SUBJECT: PUBLIC HEARING – SPECIAL USE APPROVAL AND PRELIMINARY SITE PLAN REVIEW (SU JPLN2023-0002) - Proposed Kroger D-463 Fuel Station, West side of John R, South of Larchwood (PIN 88-20-26-435-029, 88-20-26-433-019, -020 & -021), Section 26, Currently Zoned IB (Integrated Industrial & Business) District

Preliminary Site Plan and Special Use Review For City of Troy, Michigan

Project Name:	Kroger D463 Retail Fuel Center
Plan Date:	April 28, 2023
Location:	SW Corner of Larchwood Drive and John R Road
Zoning:	IB, Integrated Industrial and Business
Action Requested:	Site Plan and Special Use Approval

A landscaping plan has been provided on Sheet L-1.0. The following table discusses the development’s compliance with the landscape requirements set forth in Section 13.02.

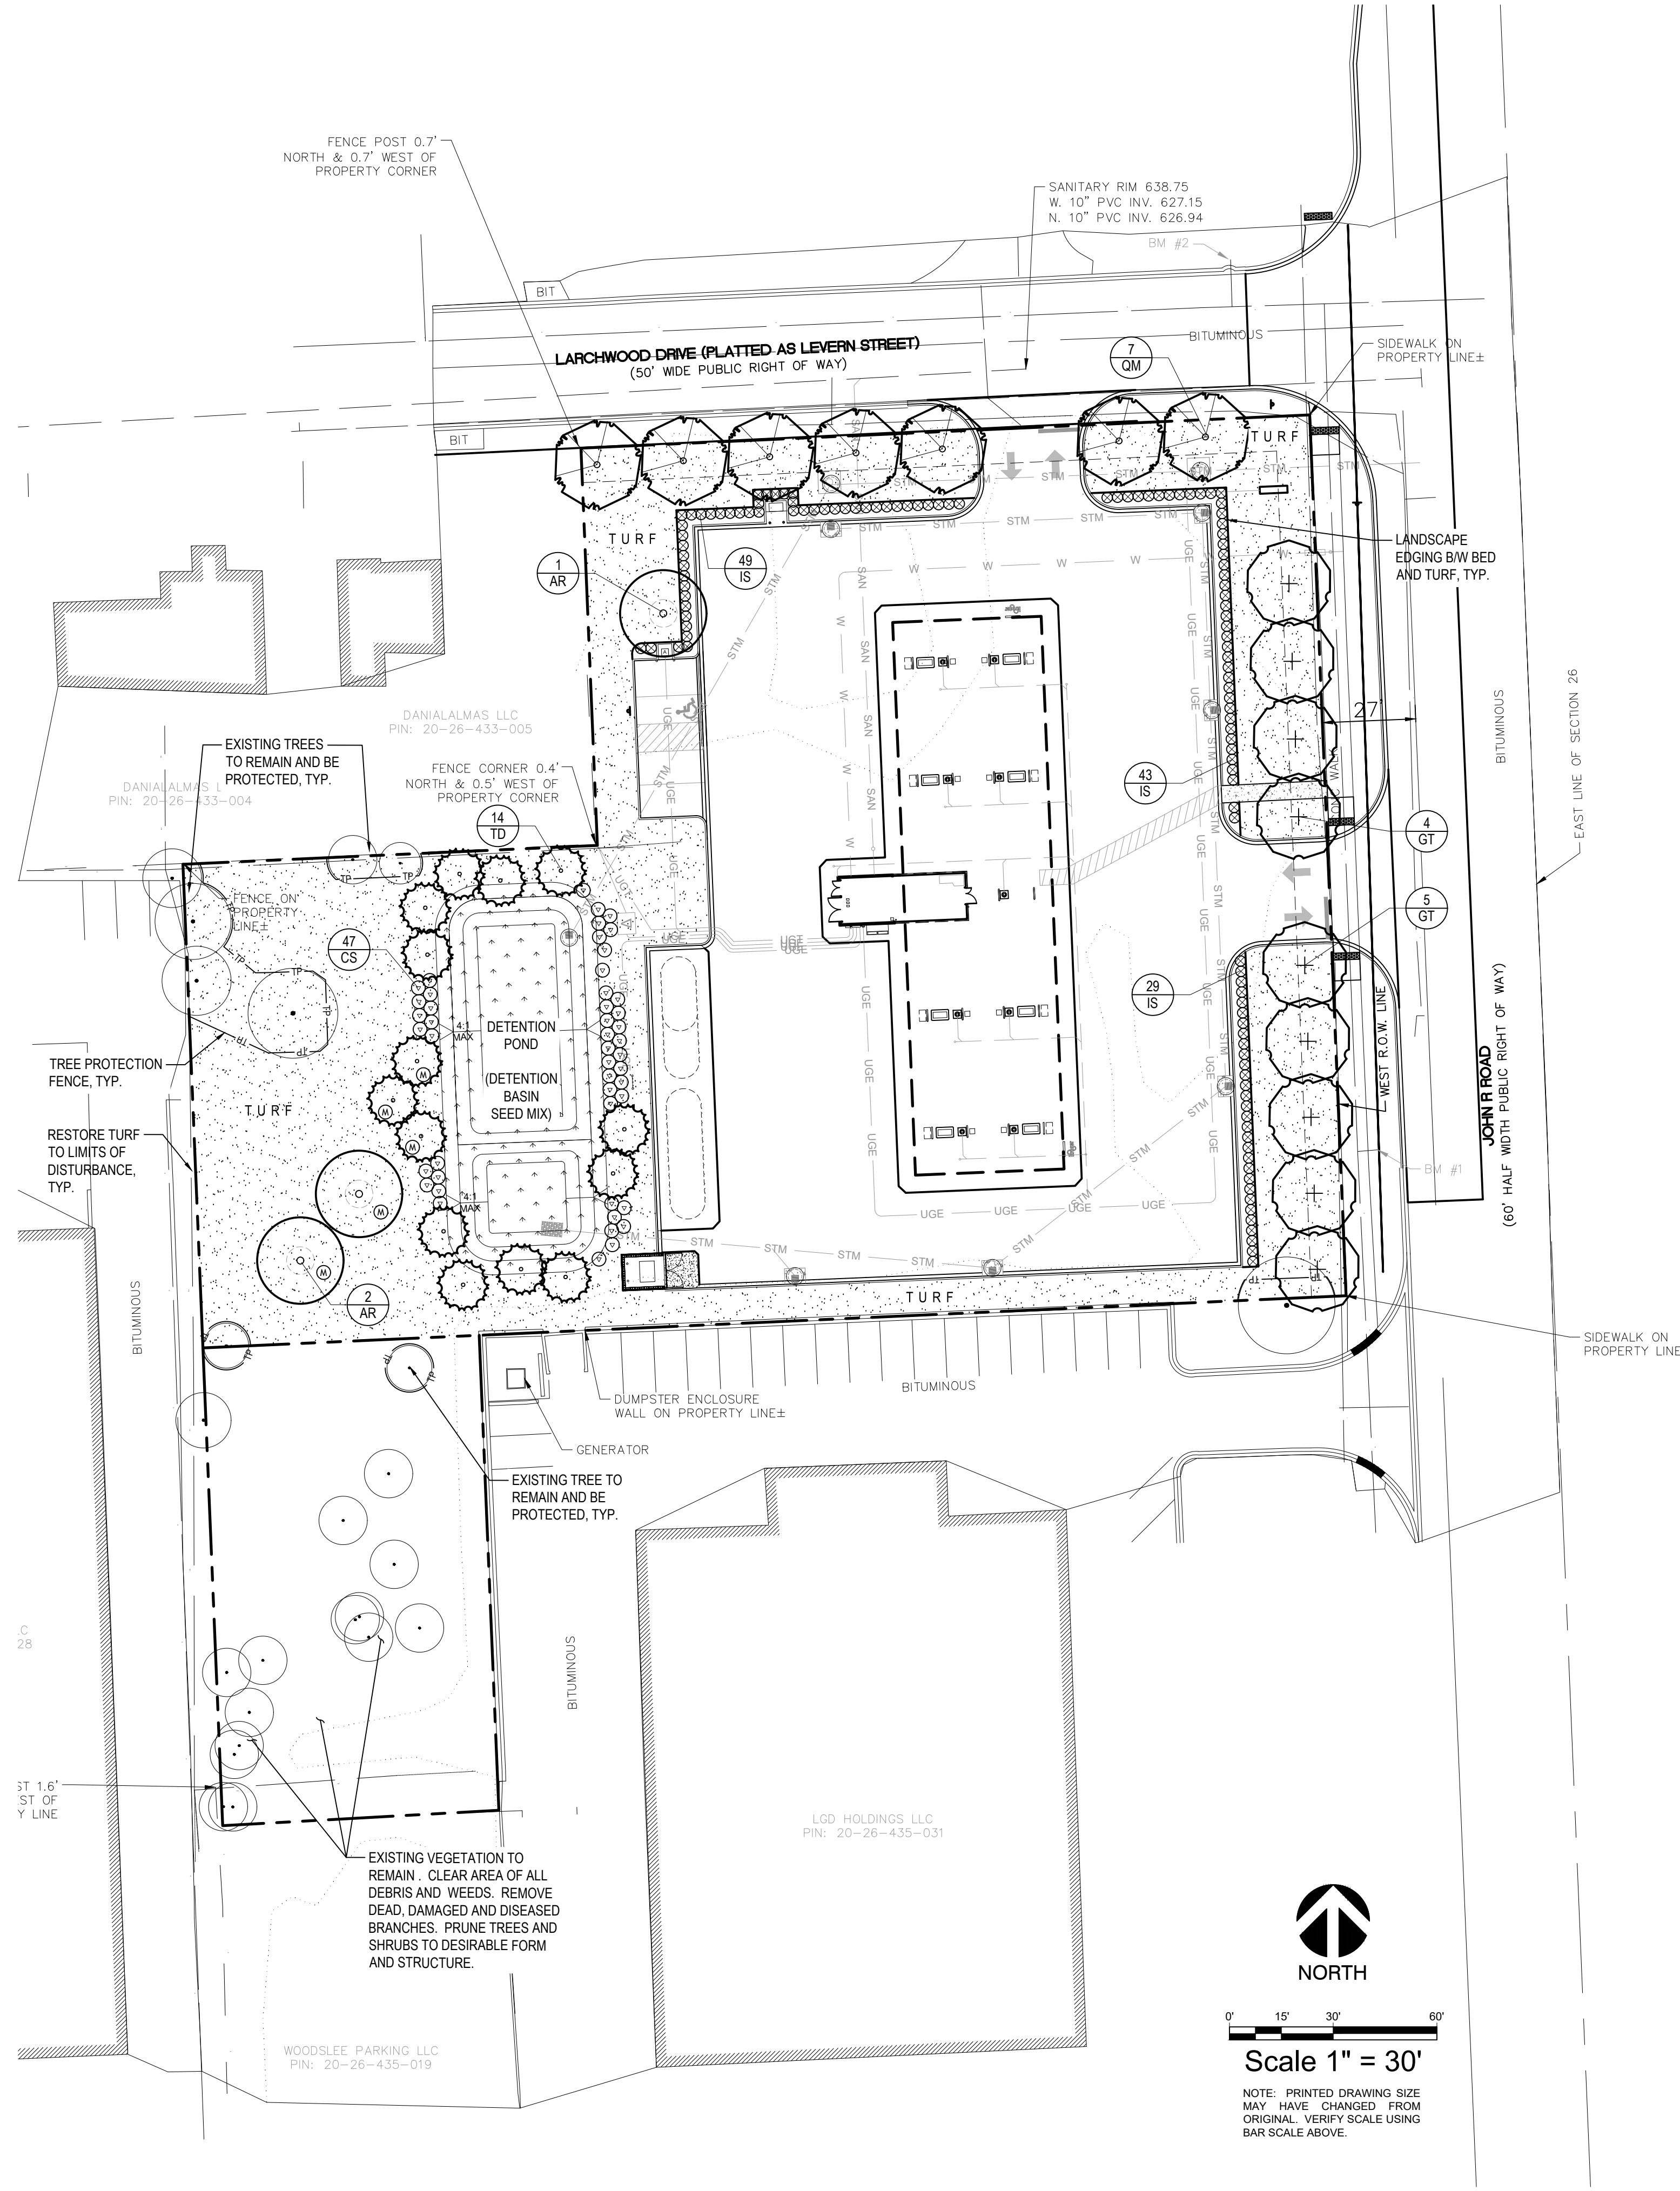
Required:	Provided:	Compliance:
Greenbelt Planting			
John R: 1 tree every 30 feet	255 ft / 30 = 9 trees	9 trees	Complies
Larchwood: 1 tree every 30 feet	210 ft/ 30 = 7 trees	7 trees	Complies
Parking Lot Landscaping			
1 tree per every 8 parking spaces	4 spaces / 8 = 1 tree	1 tree	Complies
Screening Between Land Use			
1 tree per 10 lineal feet or wall	11 large deciduous	11 trees	Complies
Overall			
<u>Site landscaping</u>	20%	47%	Complies

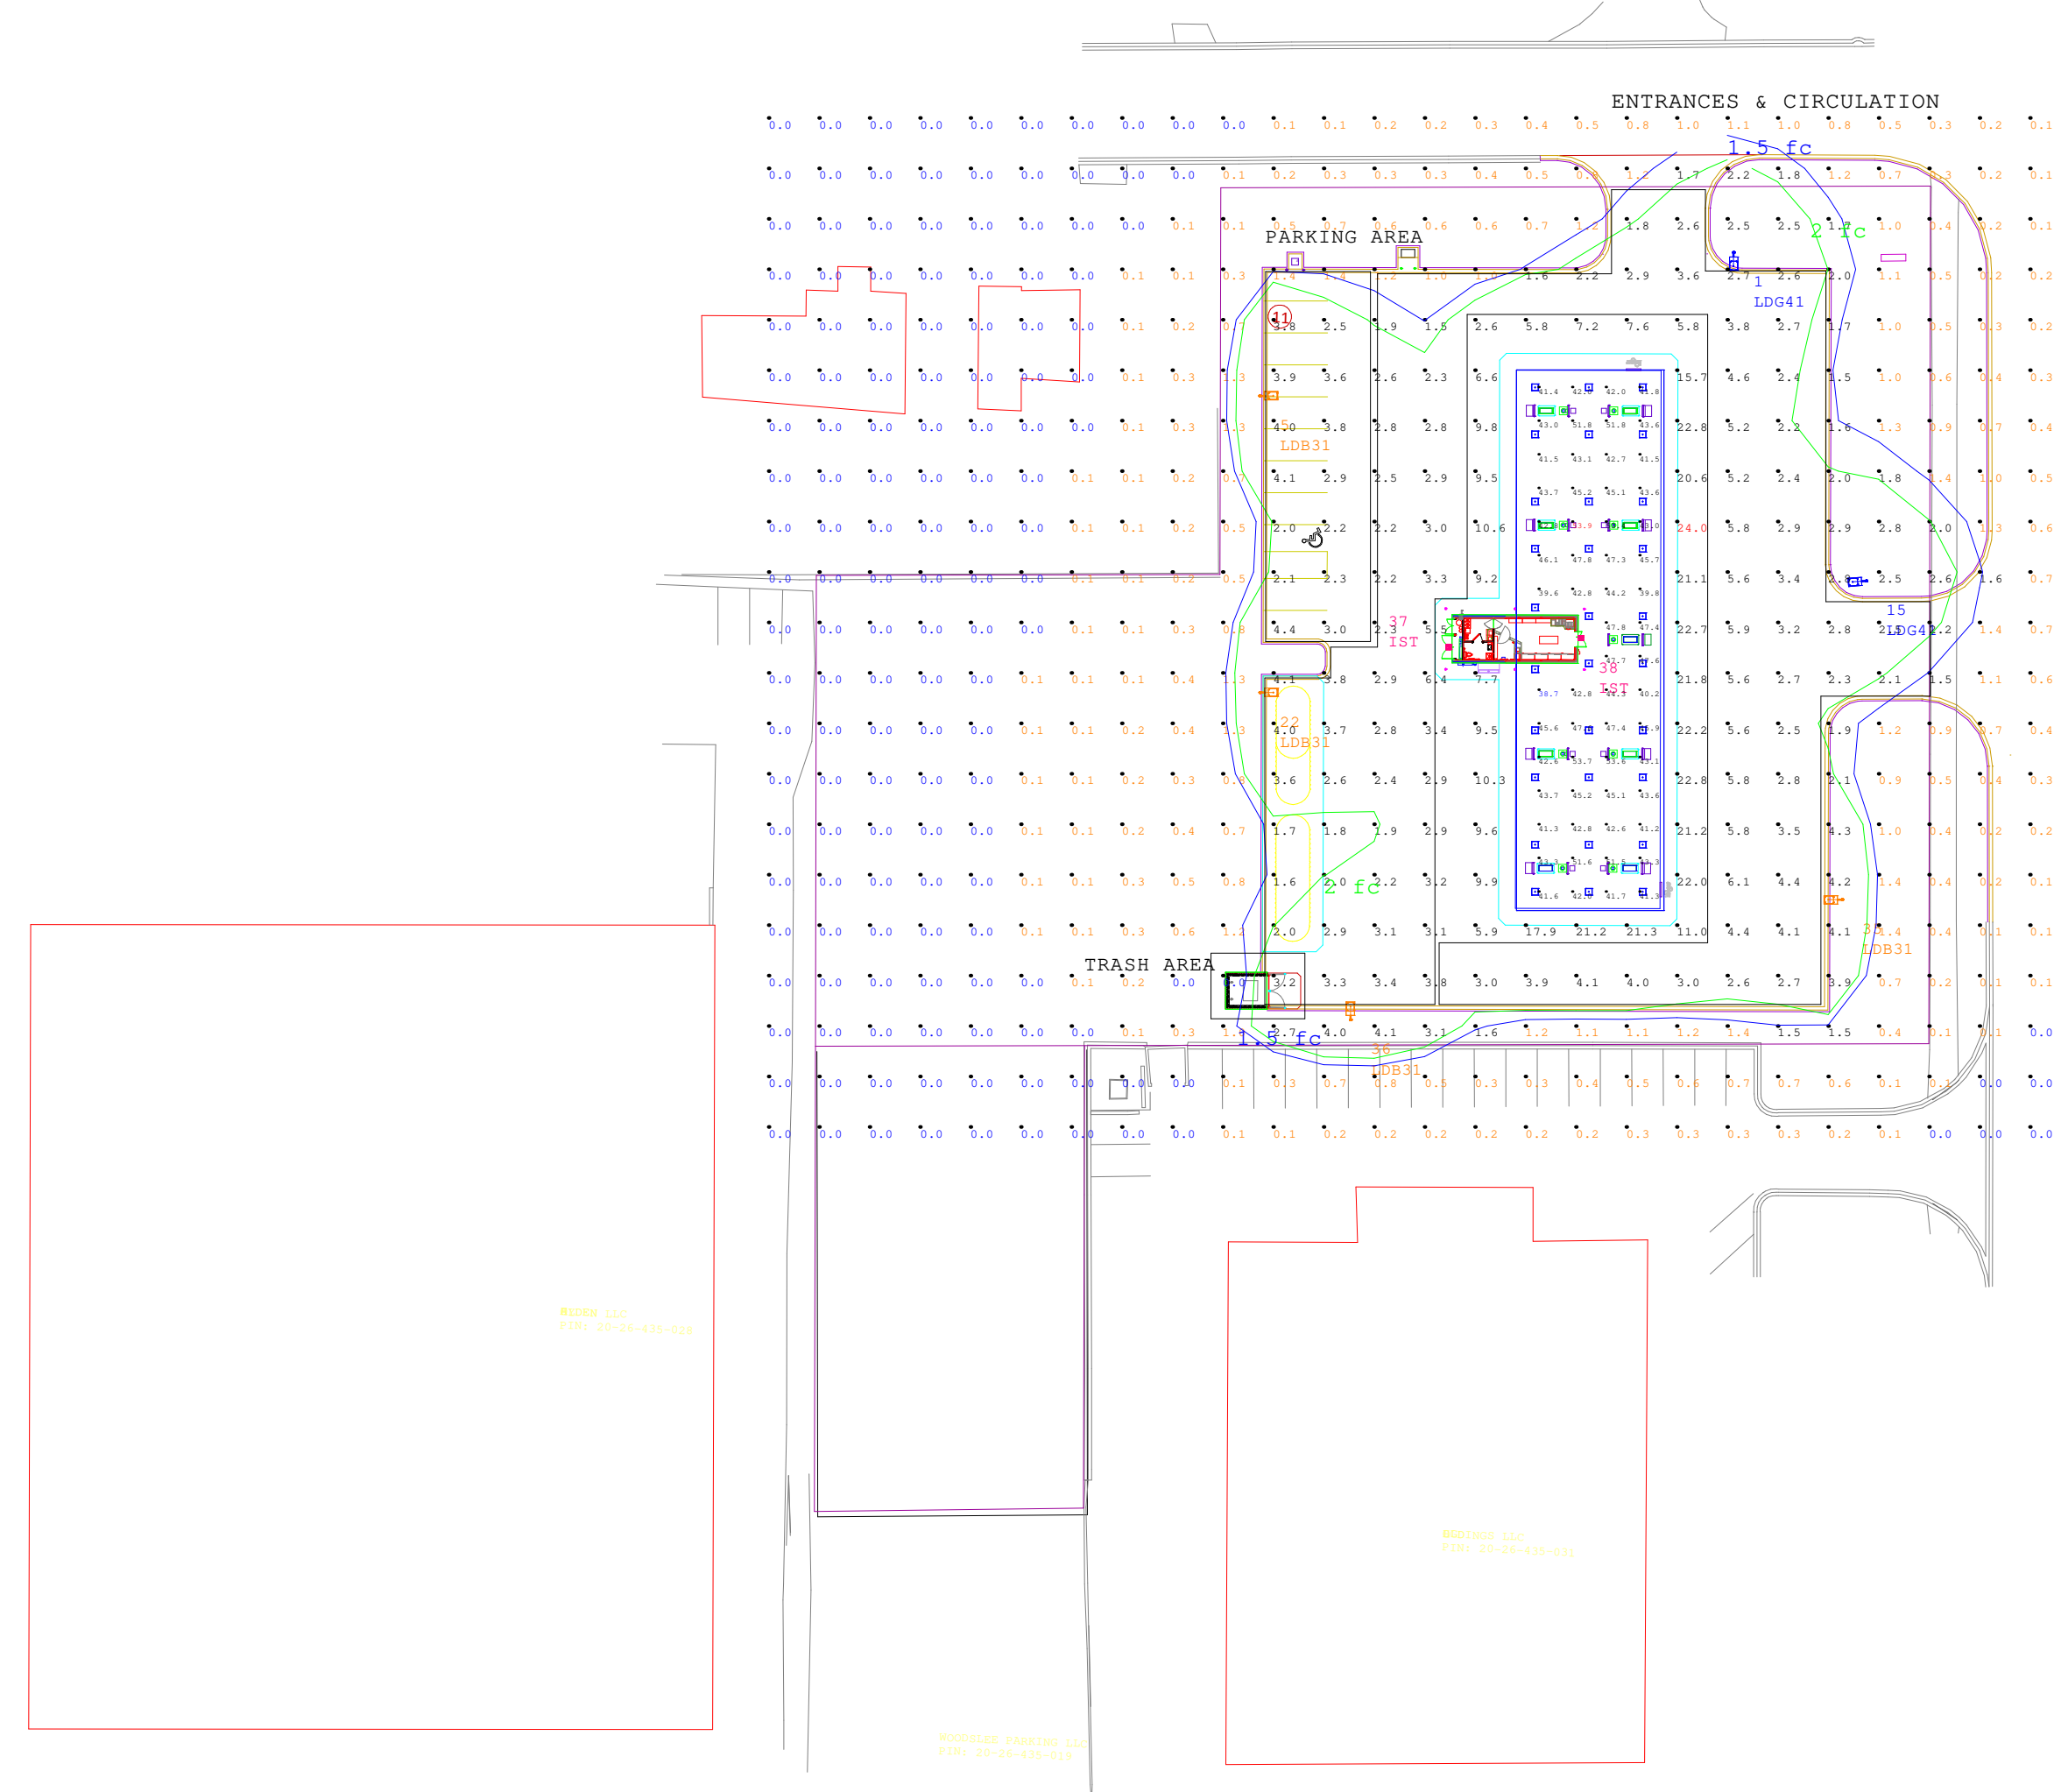
The applicant has provided a photometric plan indicating the placement of thirty (30) ceiling-mounted lights on the fueling station canopy, six (6) parking lot lights, and two (2) building lights. The photometrics are compliant at the property lines but we note that the footcandles are a maximum of 53.9 under the canopy. That is extremely bright, especially in consideration of residential across John R.

There is no specific lighting requirement for gas station canopy lighting but we note that for pole mounted lights the maximum is 20 foot candles. Because this is a special use the Planning Commission may place conditions upon the application including restricting light intensity. The applicant should reduce lighting intensity under the canopy.
